APPLICATION NO.	FILING DATE	FIRST NAMED INVENTOR	ATTORNEY DOCKET NO.	CONFIRMATION NO.
09/786,597	02/28/2001	Kenichi Hirahara	KAM/133/PC/U	1408

Office Action Summary

DETAILED ACTION

従来技術断面図 (第2図)

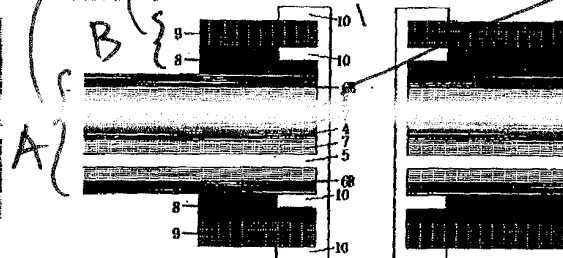
an external layer circuit board (8, 9, hereafter B) which being formed a component mounting portion laminated on one side or both sides of said internal layer circuit board (see figures 1-2),

a surface protection layer (6A, 6B), which is a cover film consisting of polyimide resin forming on an external surface of a wiring pattern (5) of said internal layer circuit board is formed in a region retreated toward the outside from a position of a through hole (11) for the through hole plated conduction portion (10).

Surface cover
or
Surface protection
layer 6A,
6B
